67 PP

DA (AMENDED)

67 PP
67 Pacific Parade DEE WHY NSW 2099

**BENSON
McCORMACK
ARCHITECTURE**

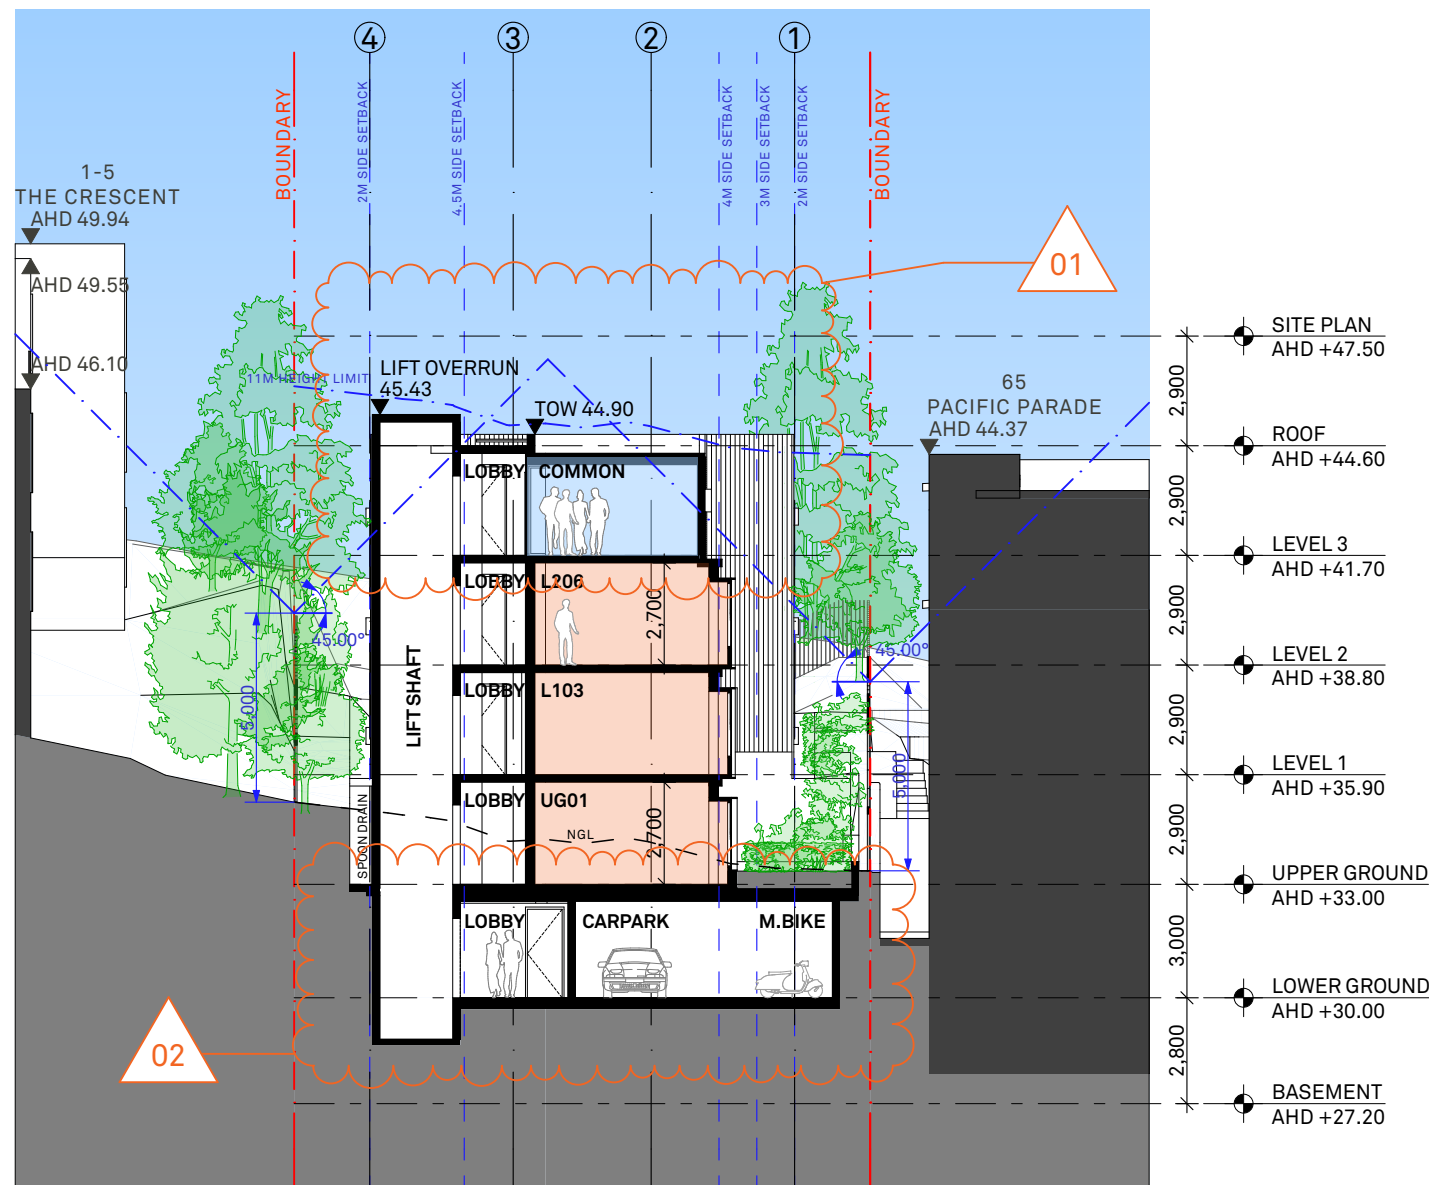
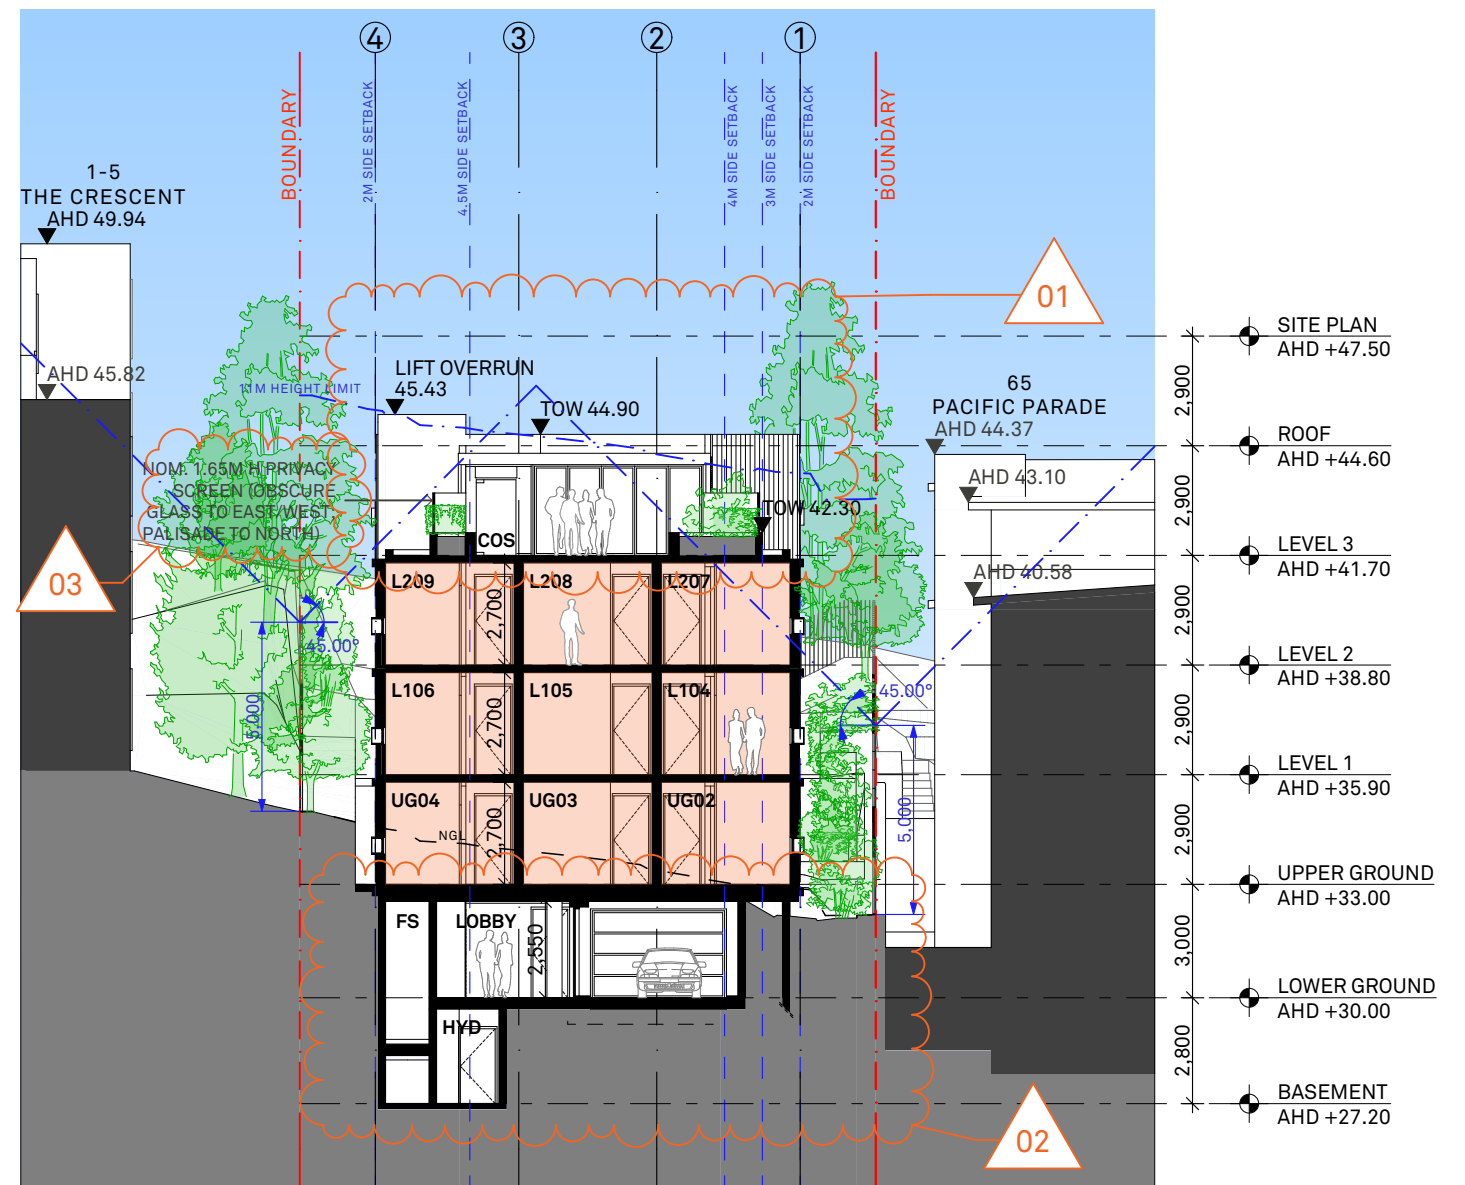
- 01 DELETE LOFT BEDROOMS; REPLACE TYPE E ROOM WITH TYPE B. INCREASE SIZE OF COMMON ROOM AND COMMUNAL OPEN SPACE
- 02 REMOVE BASEMENT FLOOR, LOWER LEVEL COMMON ROOM (LWR GRD); INSTALL CAR STACKERS
- 03 PRIVACY SCREEN TO COMMUNAL OPEN SPACE
